Project Name: Trade School & Offices

Staff Report

April 09, 2025

Case No:	24-DDP-0055
Project Name:	Trade School & Offices
Location:	5905 Fegenbush Lane
Owner(s):	Crittenden Drive Holdings, LLC
Applicant:	Sabak, Wilson, & Lingo, Inc
Jurisdiction:	Louisville Metro
Council District:	2 – Barbara Shanklin
Case Manager:	Heather Pollock, Planner I

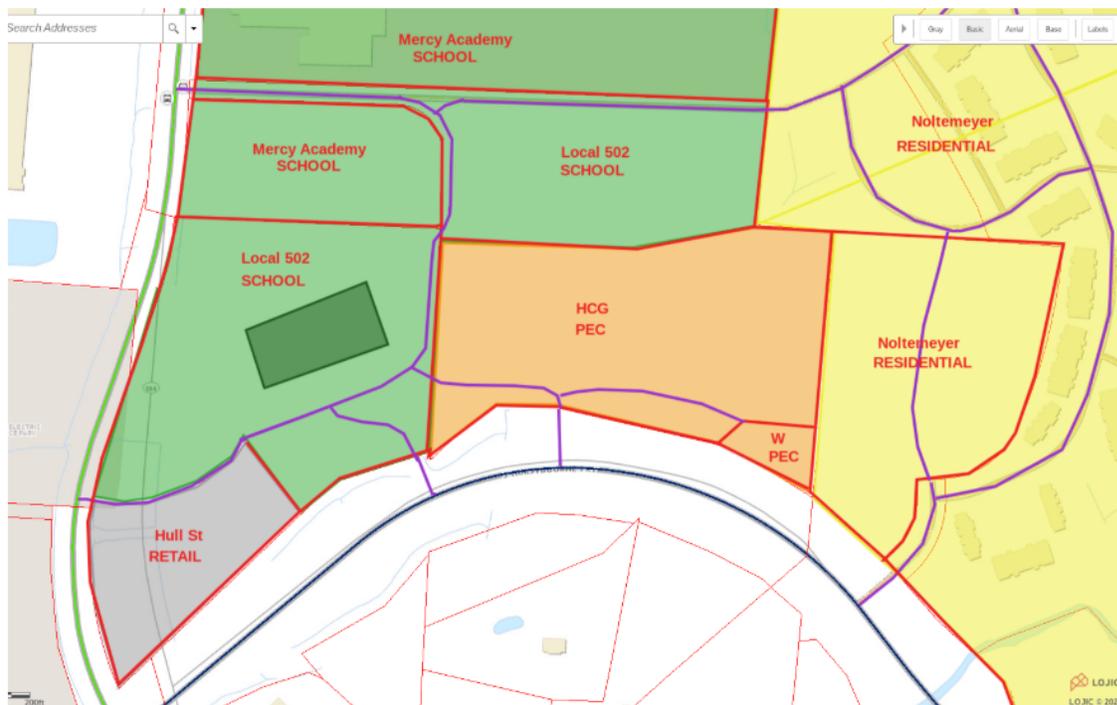
Related to a Unified Access and Circulation system (for 24-DDP-0055), below is a Strawman draft schematic for consideration by the Applicant and by the Planning Commission. This schematic appears better for all parties (including Mercy Academy) than the vague and confusing roadways in the proposed Development Plan. Edits and improvements to this Strawman schematic are welcome.

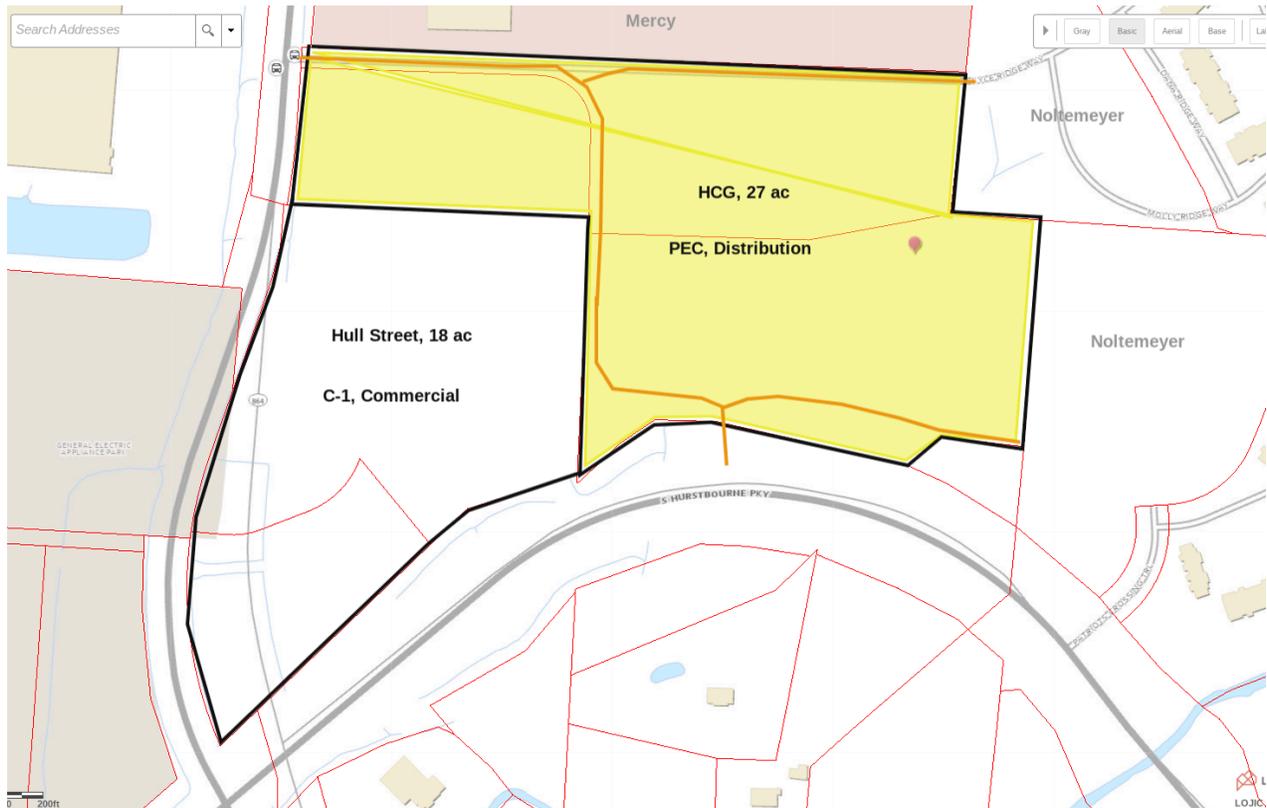
- The northeast quadrant of properties at Fegenbush Lane and Hurstbourne Pkwy has had major recent changes in the property configurations and planned uses with a new emphasis on schools and training for much of the area, due to the recent land purchases by Mercy Academy (of 5.4 acres in Dec 2023) and by UA Local 502 (of 22.5 acres in March 2024),
- The roadway network as approved for 7300 S Hurstbourne Pkwy (in 21-DDP-0055) is no longer current, and does not reflect what is best for the new property configurations and planned uses.
- **And a more straight-forward alignment for the proposed internal Access Road is needed for the Applicant's property** connecting Local 502's West Parcel (13.5 acres) and Local 502's East Parcel (9 acres).

See the 2-page attachment and graphics for more details on the recent changes to the property configurations and planned uses. Thanks for your consideration in developing an up-to-date and better Unified Access and Circulation plan, with an easy-to-follow alignment for the proposed internal Access Road . . . rather than approving a proposed Development Plan with awkward and confusing connectivity.

The proposed Roadway Connectivity (for 24-DDP-0055) needs to be up-to-date with the current planned uses for UA Local 502 and for Mercy Academy

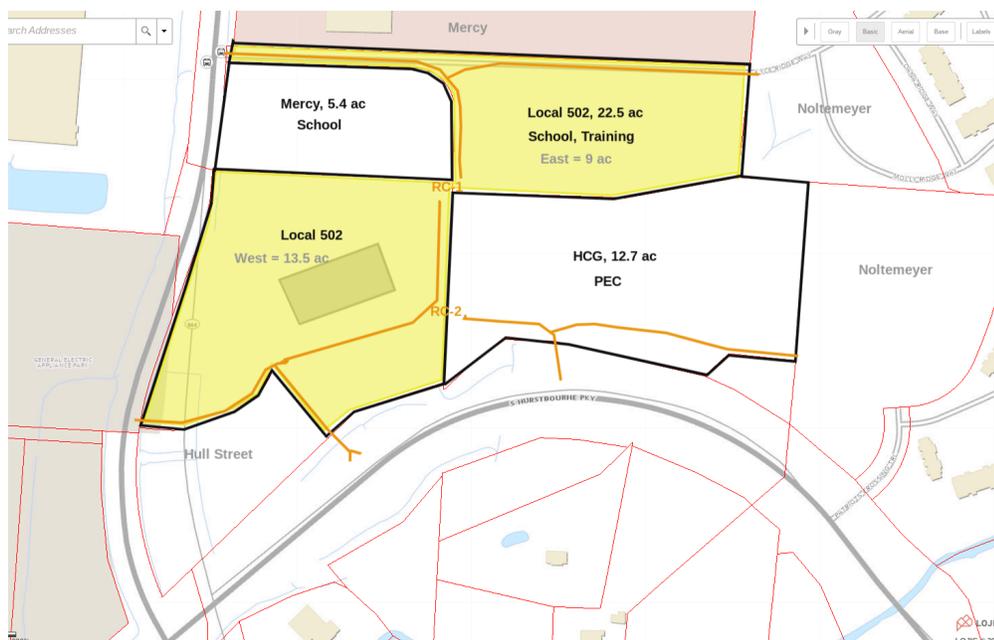
- Major changes in property configurations and property uses occurred recently with Mercy Academy adding 5.4 acres to its campus in Dec 2023, and Local 502 acquiring 22.5 acres in March 2024 for its new campus. Now in 2024, there are 3 different main properties: Local 502 = 22.5 acres; HCG = 12.7 acres; and Mercy Academy = 5.4 acres.

- Local 502 (22.5 acres, shaded in yellow below) is now the main (keystone) property in the area for roadway connectivity (instead of HCG's property). "Direct, short, and simple connections" (as described in the Comp Plan 2040 Mobility policies) should be required for a better-planned internal Access Road connecting Local 502's West and East parcels.

Connectivity schematic roughly illustrating the new Development Plan (dated 11-26-2024)

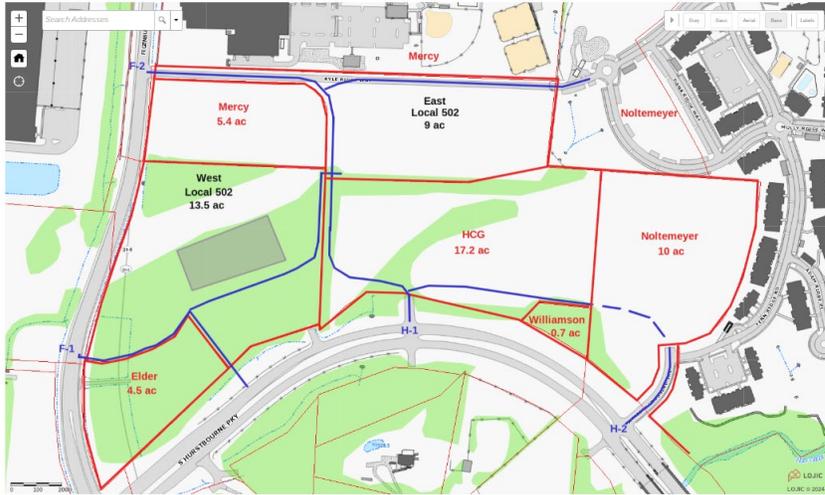
- As a neighboring property owner, from my view (as roughly illustrated by the LOJIC schematic below) the Access Drive on the new proposed Development Plan (11-26-2024) appears to be a significant improvement for roadway connectivity serving the Applicant's two parcels.
- However, the proposed roadway alignment in the northeast portion of the 13.5-acre Site still appears to be awkward and confusing.
- It also appears that some additional pavement edges are needed to define the Access Drive across the 13.5-acre Site, to help separate the connecting roadway from the truck loading and parking areas. And 24-DDP-0055 should clearly provide crossover rights for the adjacent properties.

Contrary to the vague General Note #16 on the proposed Development Plan, a **Unified Access and Circulation plan should be prepared now (with 24-DDP-0055), instead of later. And the Unified Access and Circulation system should cover the Applicant's entire 22.5-acre property.** Section 1.6 (Appendix 6A) of the Land Development Code (LDC) states that "integrated development sites comprised of more than one building or more than one lot are not considered separate properties in relation to the access management standards of this code."

My proposed connectivity schematic (as a better option to consider)

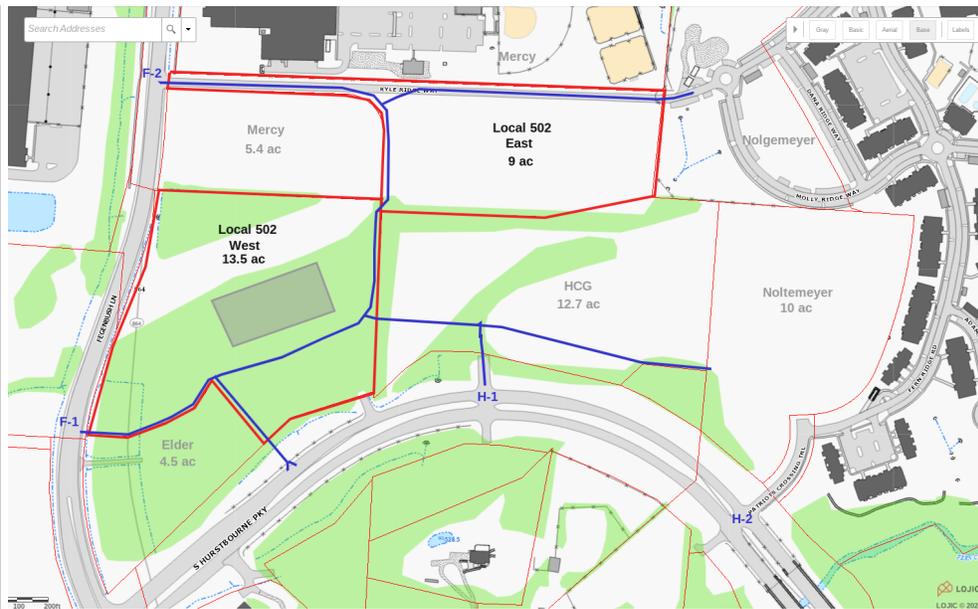
A well-planned Unified Access and Circulation system would only require a minimum amount of communication and cooperation among the few neighboring parties and Louisville Metro. Although the Unified Access and Circulation schematic (as illustrated below) may not be the best option, it appears to be a much better Access and Circulation system than the proposed Development Plan. This type of connectivity option provides "direct, short, and simple connections" (as described in the Comp Plan 2040 Mobility policies), which are beneficial for the area and which minimize the probability of a high-speed, cut-thru roadway across these properties.

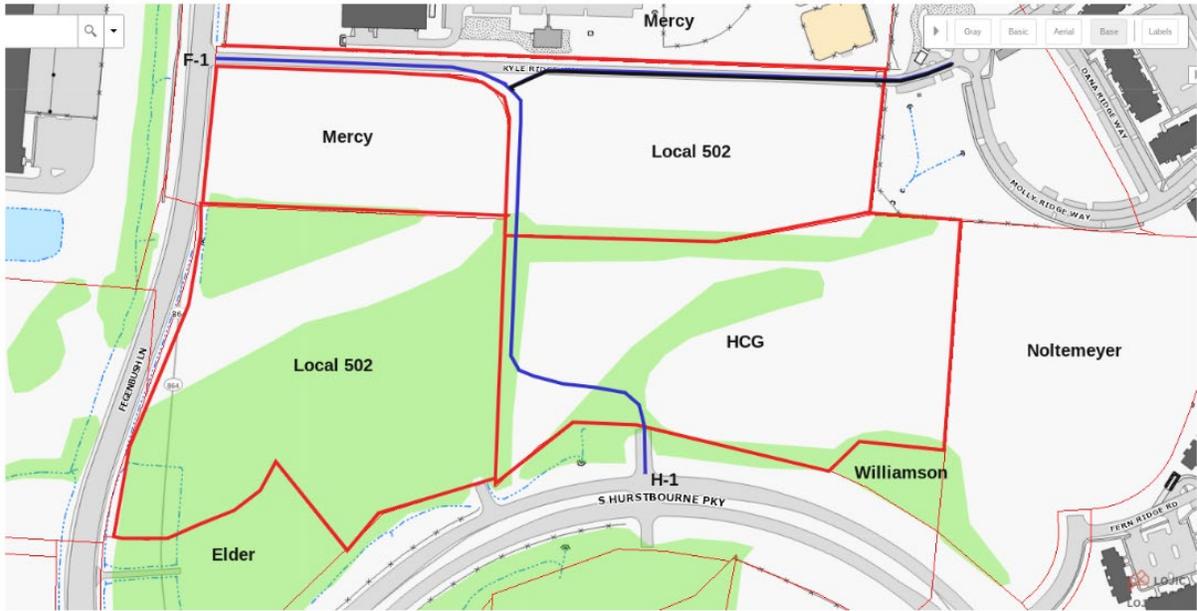
Also for Louisville Metro's consideration, now that the proposed uses are better defined for the area (see LOJIC drawing below) and since all of the properties have excellent existing access to Hurstbourne Pkwy and/or Fegenbush Lane:

- Maybe fewer crossover connections would be less confusing and more advantageous for all.
- For example, since Mercy Academy's new 5.4-acre property (located south of Kyle Ridge Way) is split from the original Mercy campus by Kyle Ridge Way, Mercy Academy may prefer fewer PEC and other properties connected to Kyle Ridge Way . . . in order to avoid a cut-thru shortcut between Hurstbourne Pkwy and Fegenbush Lane.
